Model: Model-K3		Date: 5-Sep-02	No.: RH310001
Subject: SG3 Option ROM History (Model K3)		Prepared by: M. Mano	
From: Technical Services sec. Service Planning Dept.			
Classification:	<input type="checkbox"/> Troubleshooting <input type="checkbox"/> Part information <input type="checkbox"/> Action required <input type="checkbox"/> Mechanical <input type="checkbox"/> Electrical <input type="checkbox"/> Service manual revision <input type="checkbox"/> Paper path <input type="checkbox"/> Transmit/receive <input checked="" type="checkbox"/> Retrofit information <input type="checkbox"/> Other ()

Firmware history of the optional SG3 for Model K3.

Model: Model K3		Date: 3-Oct-02	No.: RH310005
Subject: Service Manual Correction (Model K3)		Prepared by: M.Mano	
From: Technical Services sec. Service Planning Dept.			
Classification:	<input type="checkbox"/> Troubleshooting <input type="checkbox"/> Part information <input type="checkbox"/> Action required <input type="checkbox"/> Mechanical <input type="checkbox"/> Electrical <input checked="" type="checkbox"/> Service manual revision <input type="checkbox"/> Paper path <input type="checkbox"/> Transmit/receive <input type="checkbox"/> Retr

**Windows 95**

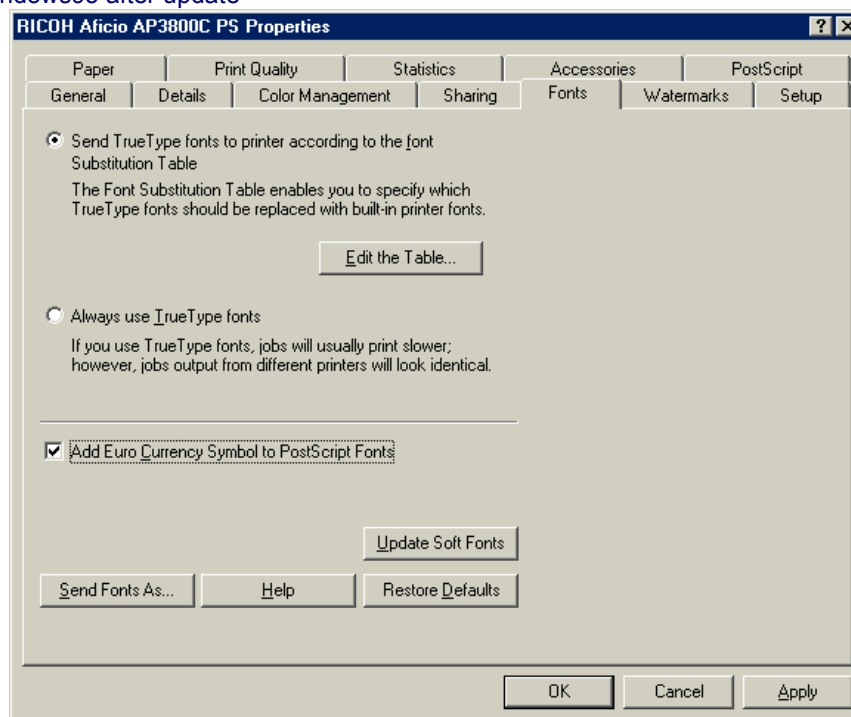
Then the "Add Euro Currency Symbol to PostScript Fonts" check box is available.

Check "Add Euro Currency Symbol to PostScript Fonts". (Before update, the check box doesn't work.)

Windows 2000

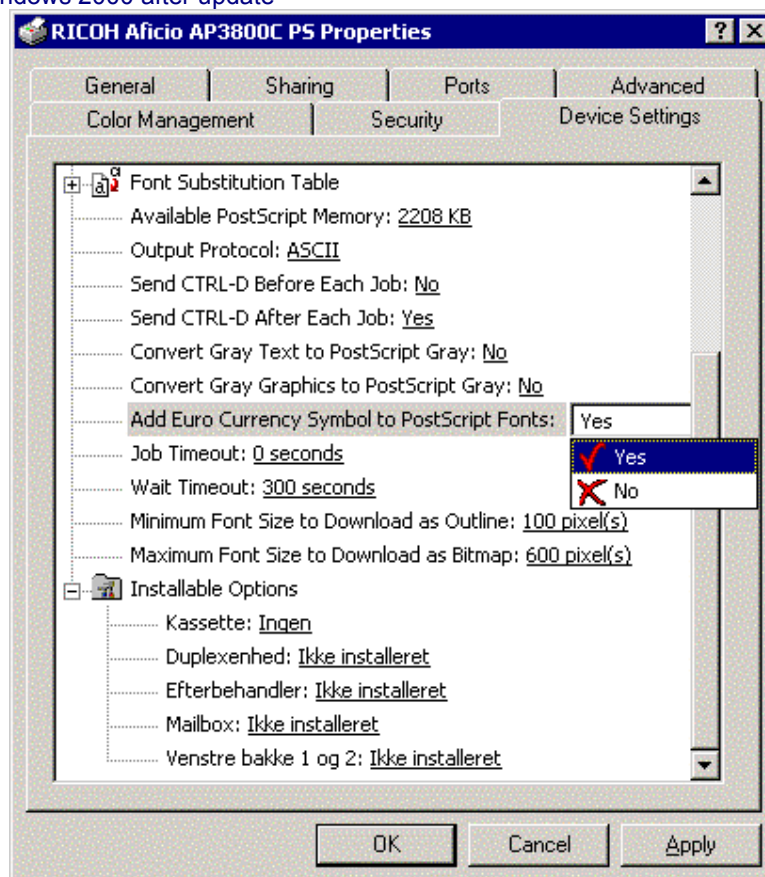
Update the printer driver to v5.5.2 or later.

Then the "Add Euro Currency Symbol to PostScript Fonts" check box is displayed.

Check "Add Euro Currency Symbol to PostScript Fonts".

Cause

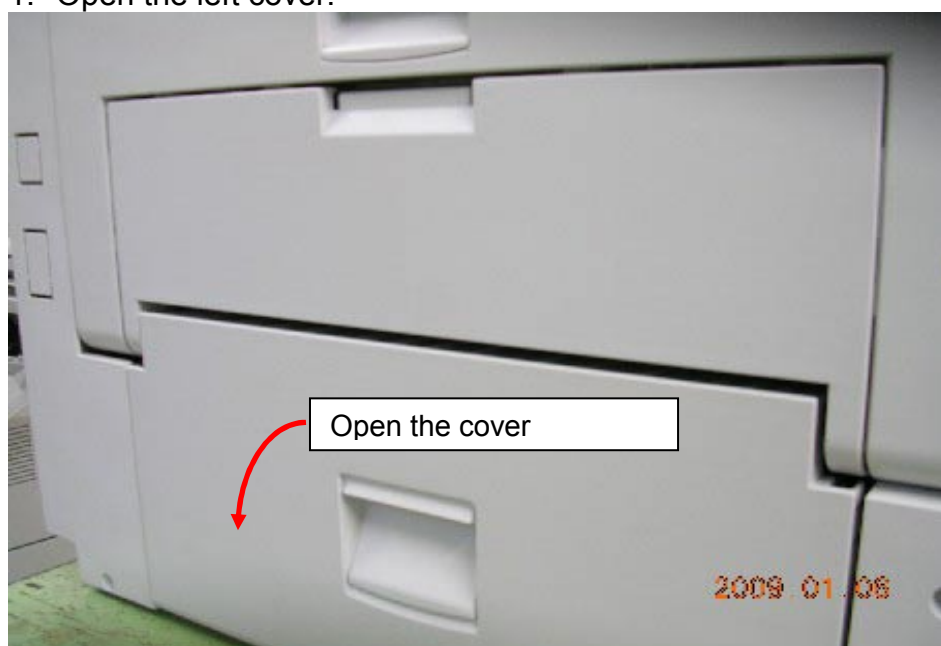
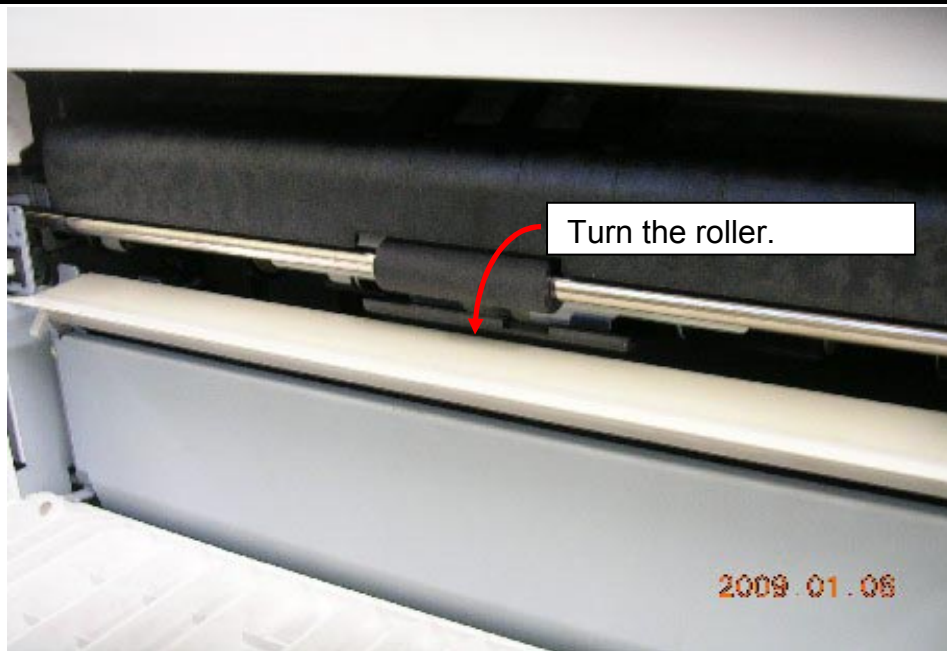
The stepper motor- DC24V 12.6W (P/N AX020083) does not rotate because of vaporized Glue dried on the motor shaft. (Motor locked.)
